“Some Figures and thoughts”

Mickey Felton
EMC Corporation
07-377r0

RTTL figure:

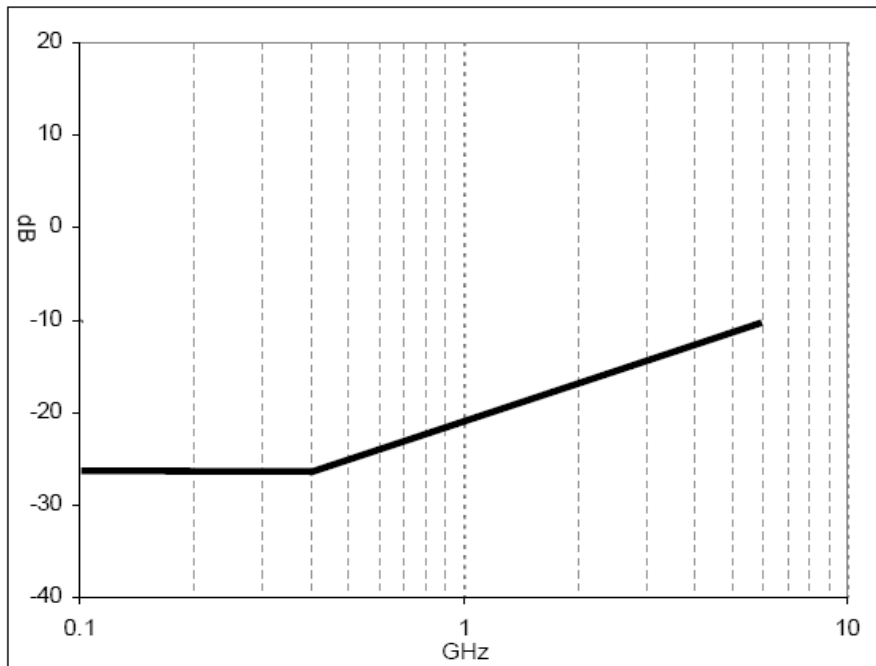
Thoughts on existing graphs

- Graphs that are some what open to interpretation should be labeled at all “interesting points” i.e.
 - Start
 - End
 - Knee
- Also believe only showing the exact fit in the graph would also help (ie stopping at 0.1 was helpful, stopping long before 10G seems strange.)
